ADDENDUM NO. 02

PROJECT: **VIGO COUNTY SECURTY CENTER**
Terre Haute, Indiana 47807

ARCHITECT: **DLZ INDIANA, LLC**
157 East Maryland Street
Indianapolis, Indiana 46204
317.633.4120
DLZ Project Number: 1663-1190-90

DATE: **September 19, 2019**

BORROWED LITE ELEVATIONS - 1' - 0" = 1/4"

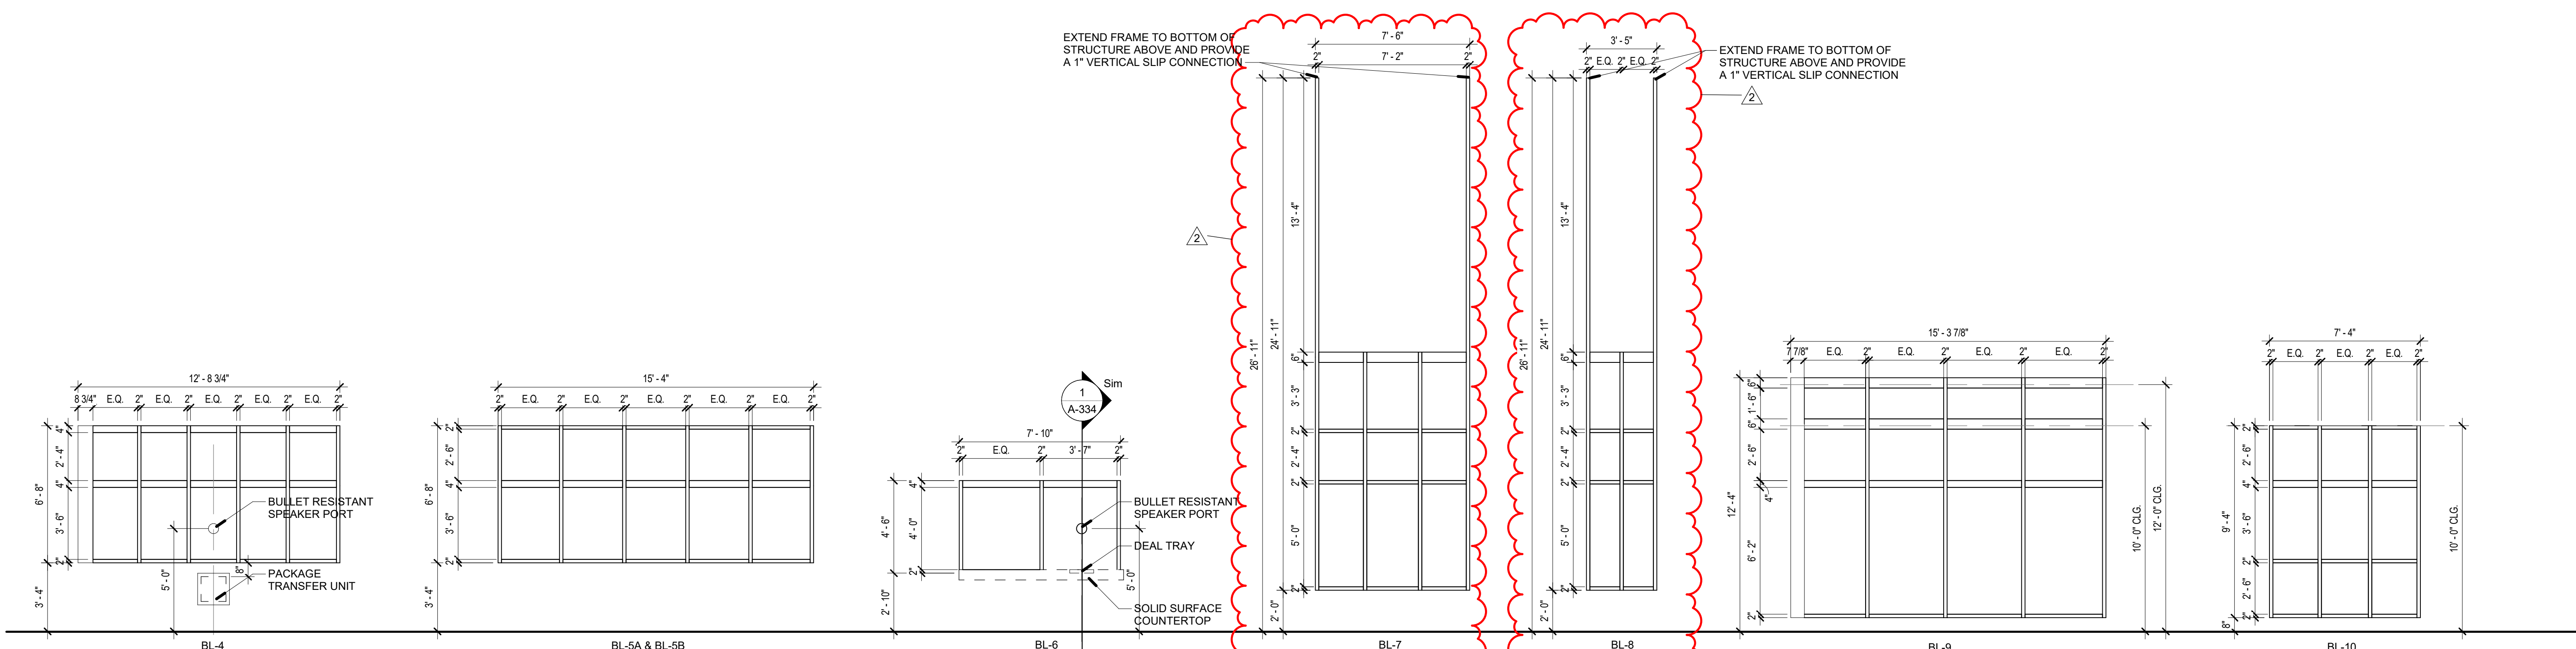
- a. Borrowed Lite Elevation BL-7.
 - 1. Extend end frames vertically to bottom of structure above and provide 1” vertical slip connection.
 - 2. Deleted stray lines to clarify frame members.
- b. Borrowed Lite Elevation BL-8.
 - 1. Extend end frames vertically to bottom of structure above and provide 1” vertical slip connection.

EXTEND FRAME TO BOTTOM OF STRUCTURE ABOVE AND PROVIDE A 1" VERTICAL SLIP CONNECTION

EXTEND FRAME TO BOTTOM OF STRUCTURE ABOVE AND PROVIDE A 1" VERTICAL SLIP CONNECTION

1 OVERALL PENTHOUSE PLAN - ELECTRICAL
E-202-BC SCALE: 1/8" = 1'-0"
NORTH

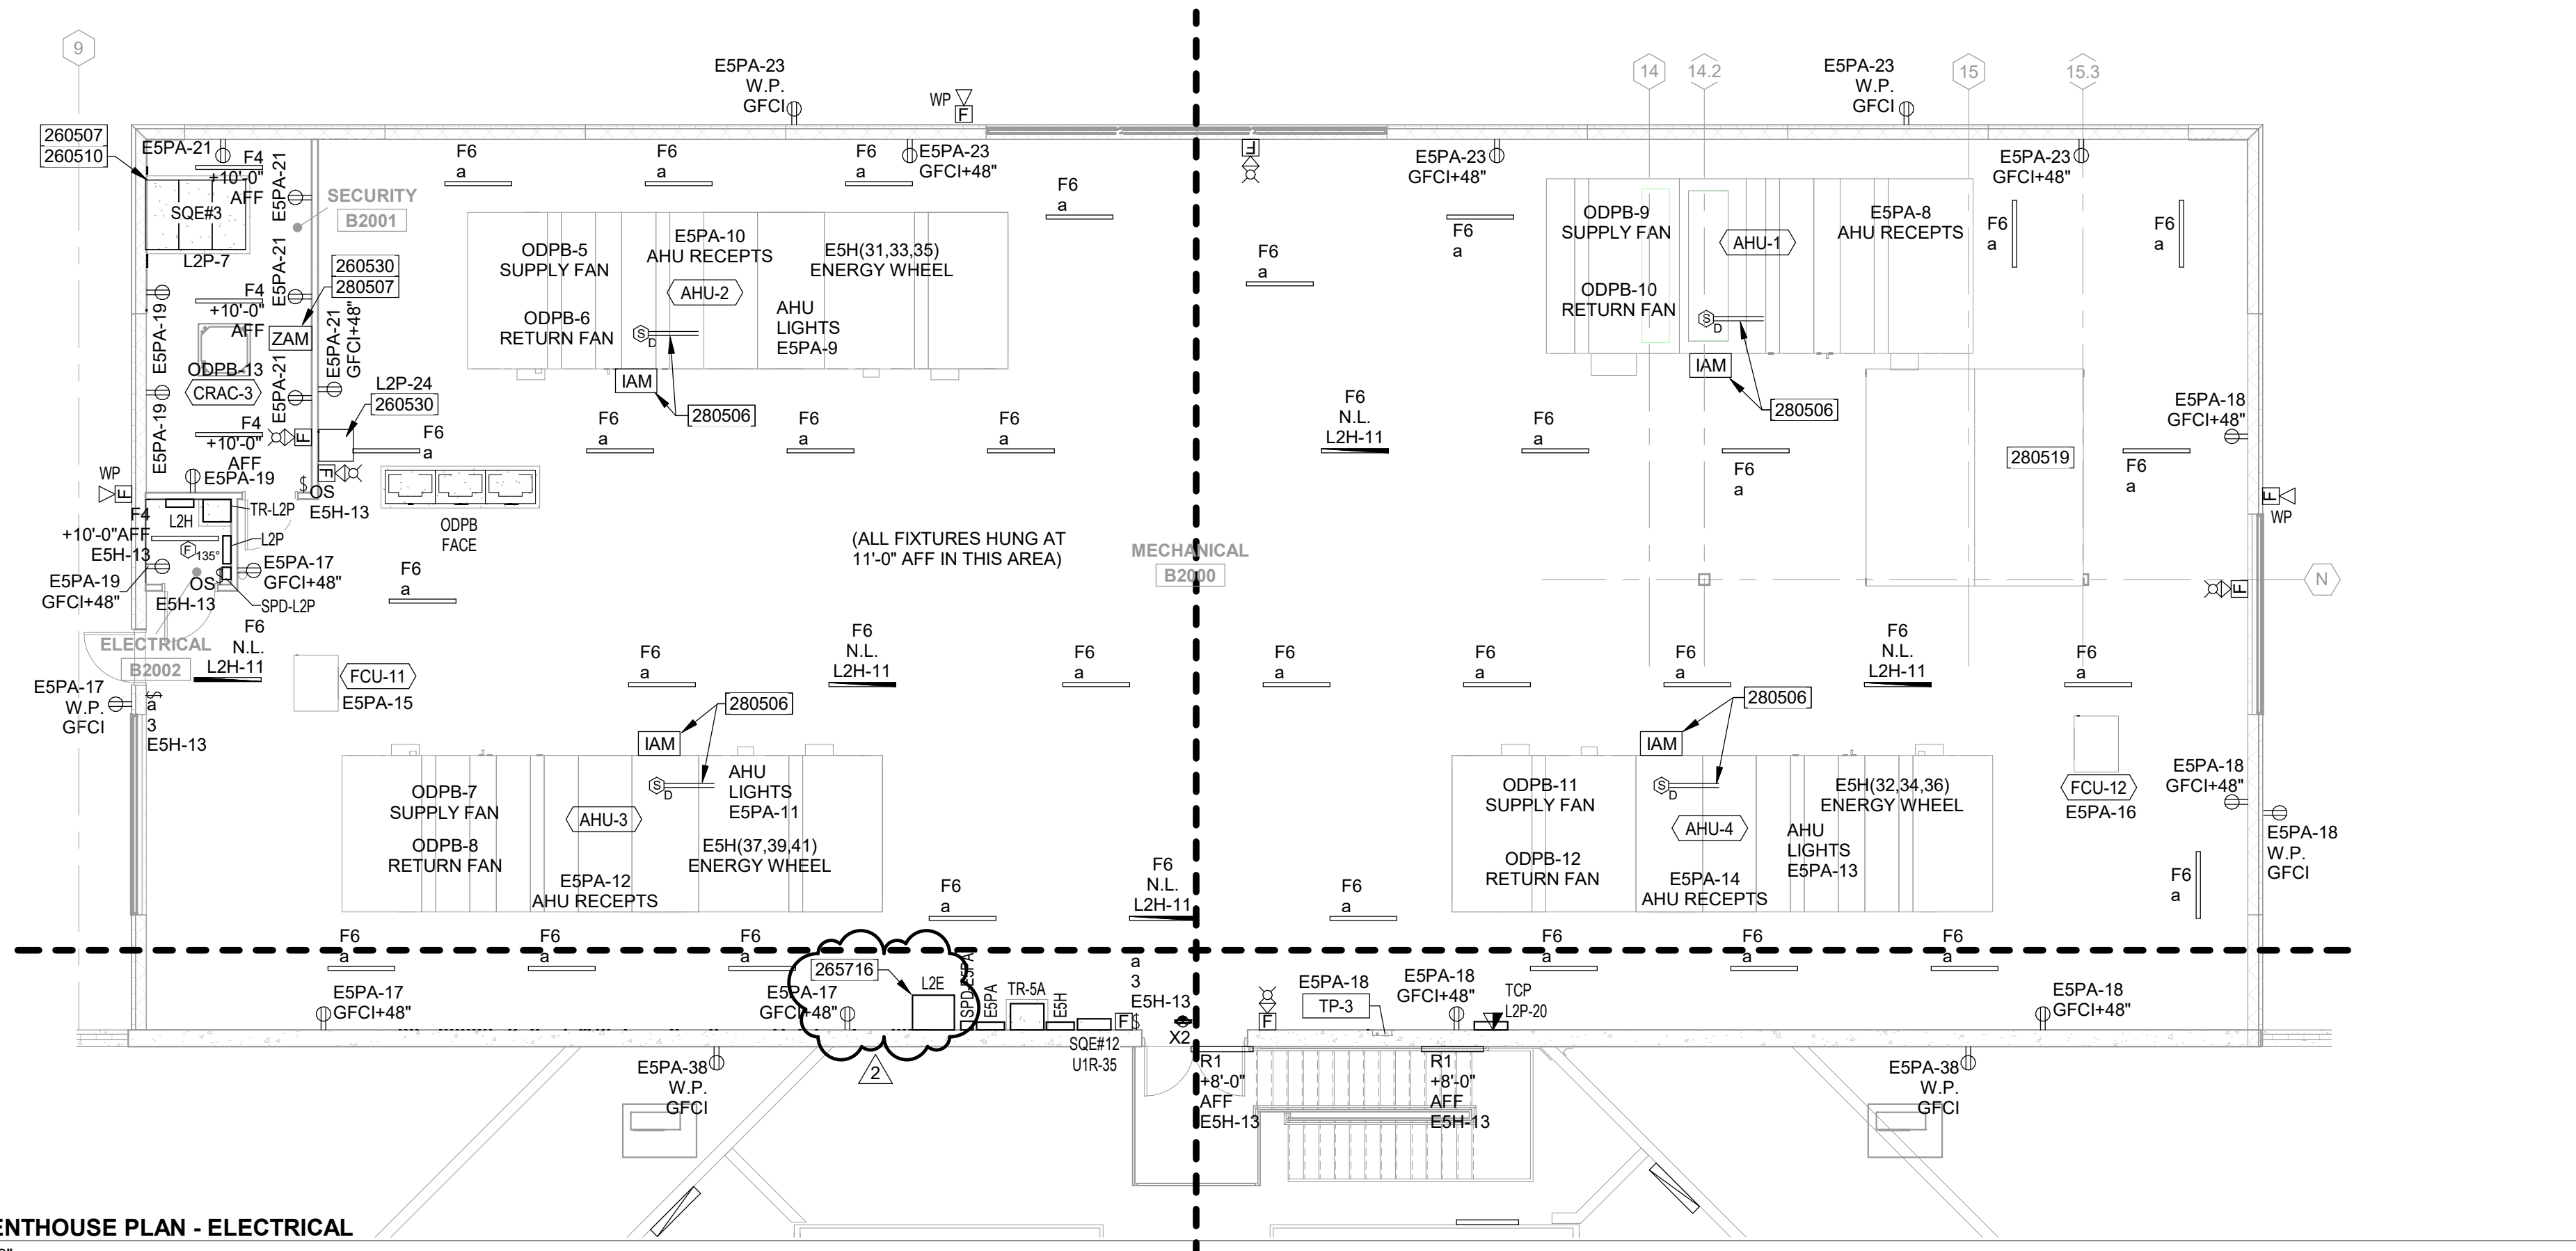
- a. Replace drawing in its entirety with attached.

FIRST FLOOR SECURITY ELECTRONICS PLAN - AREA D
ES-104 SCALE: 1/8" = 1'-0"
NORTH

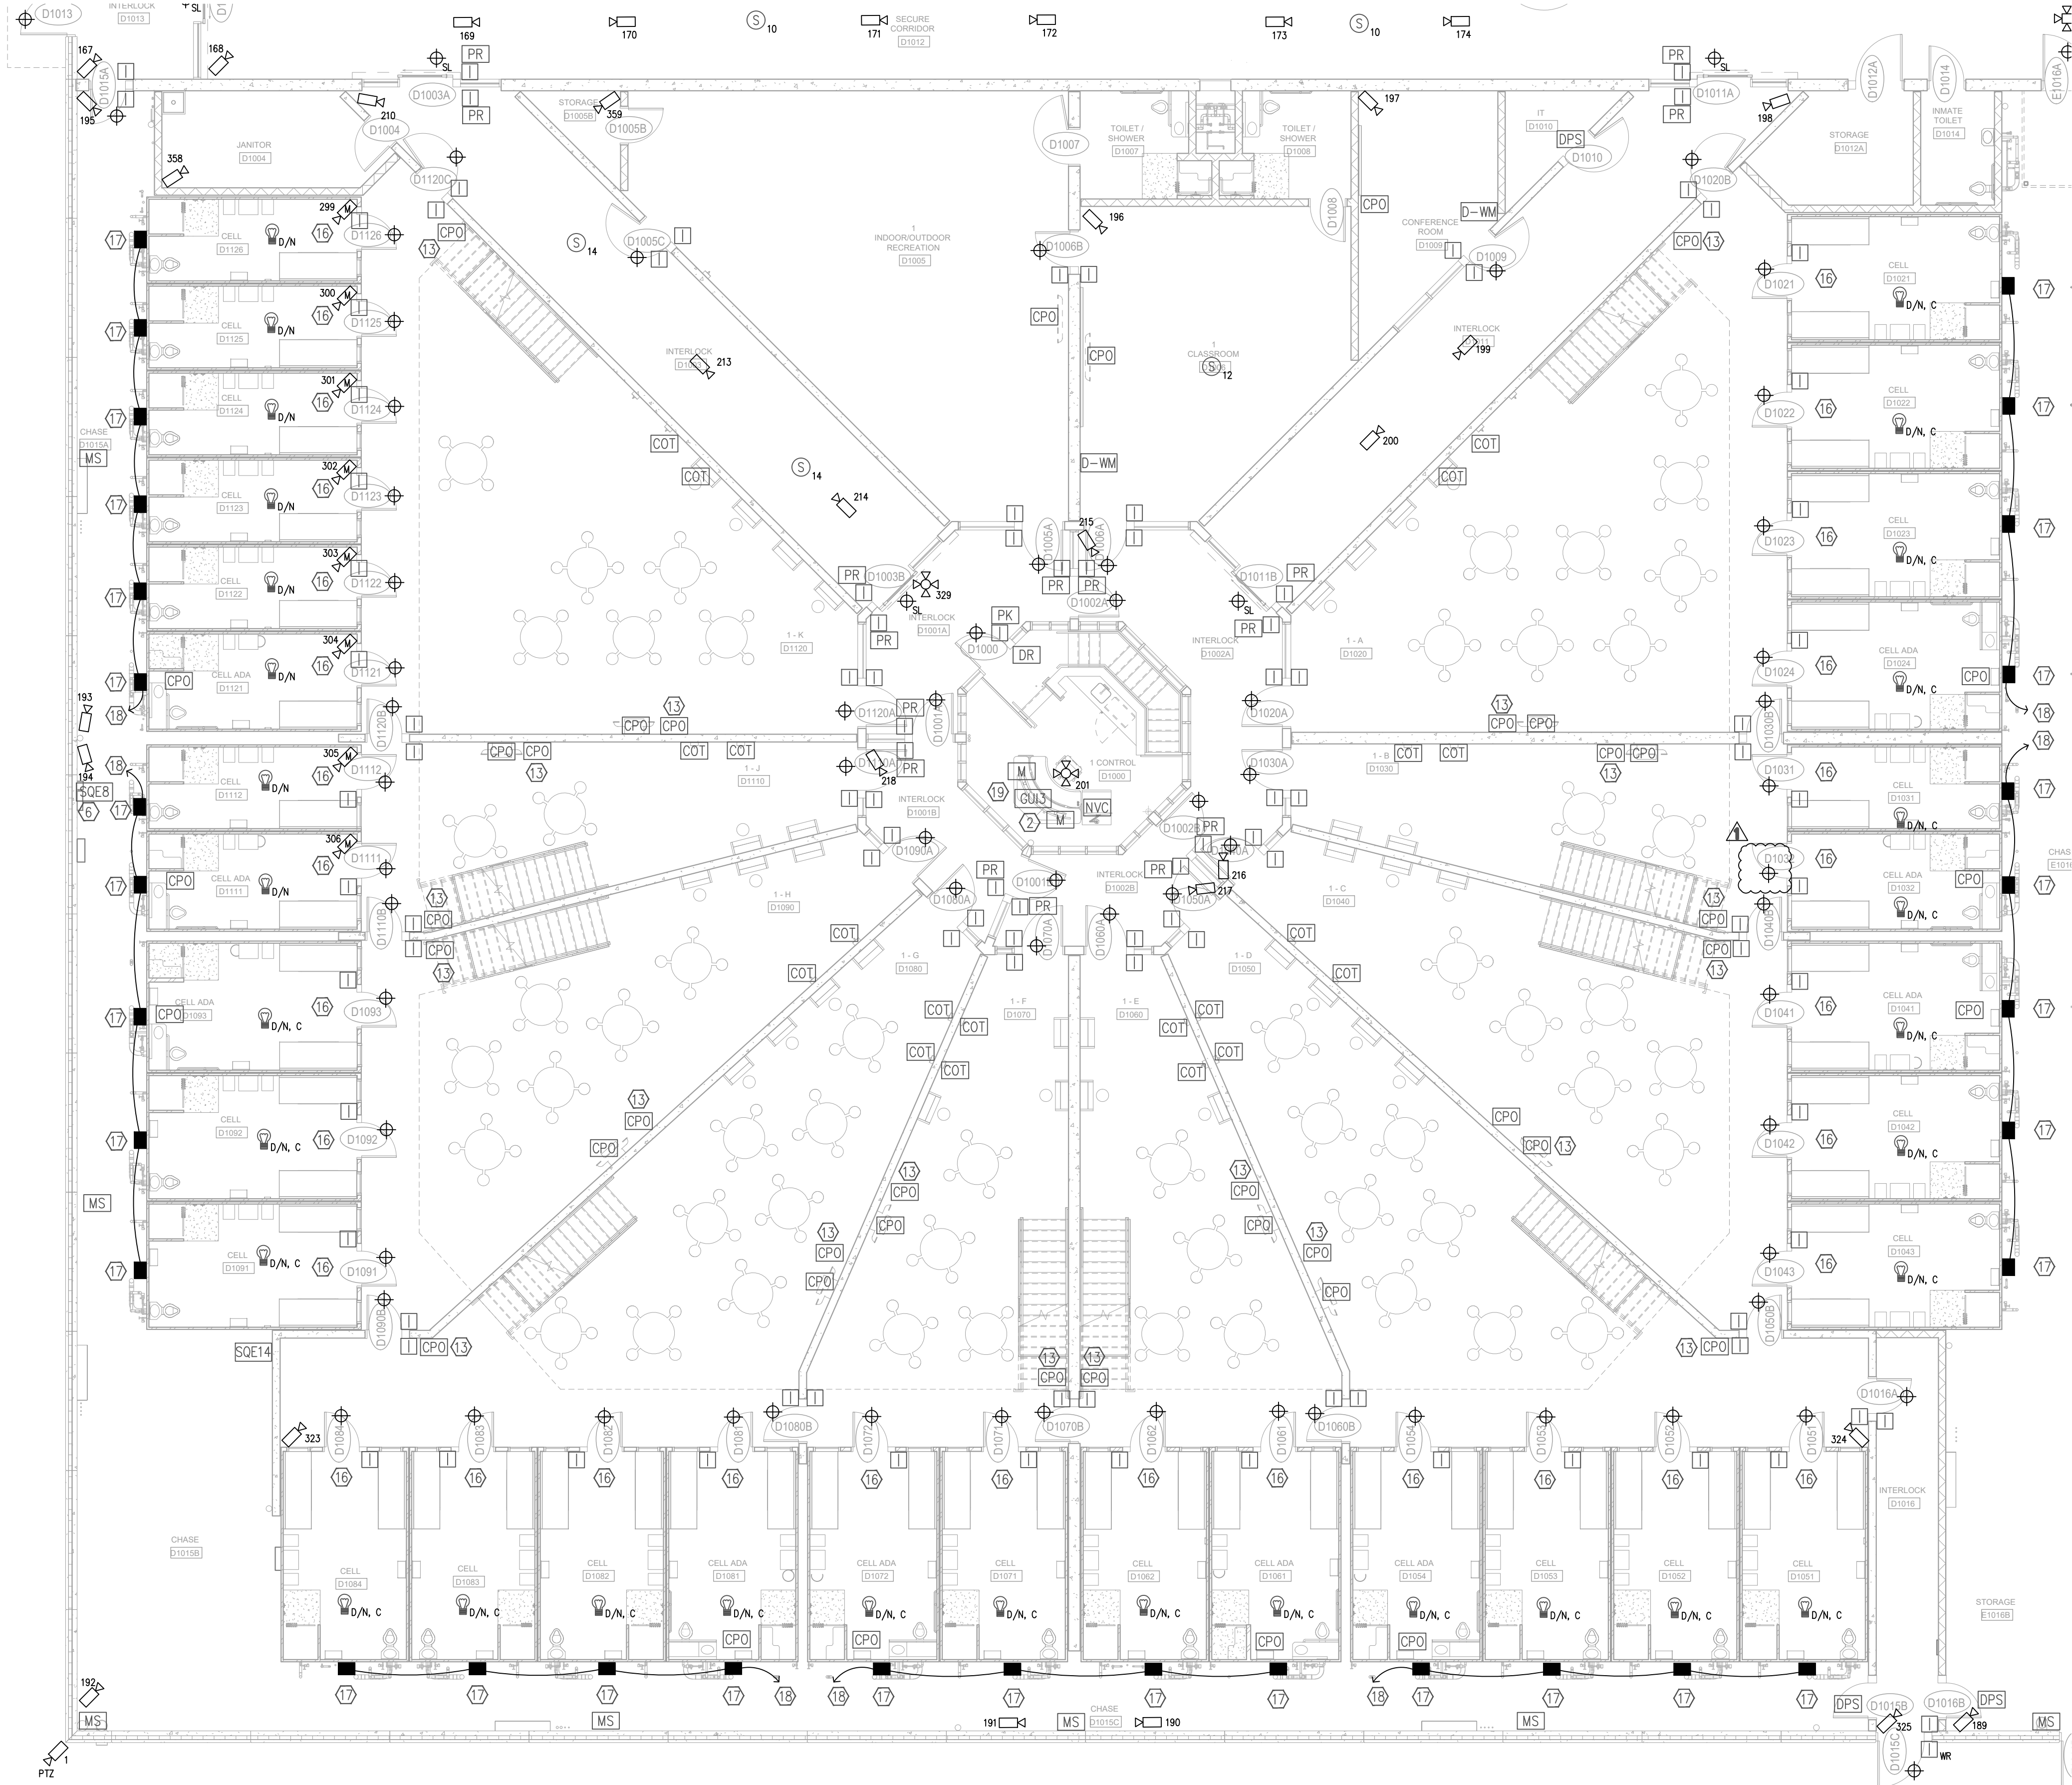
- a. Added electric door control to door D1032
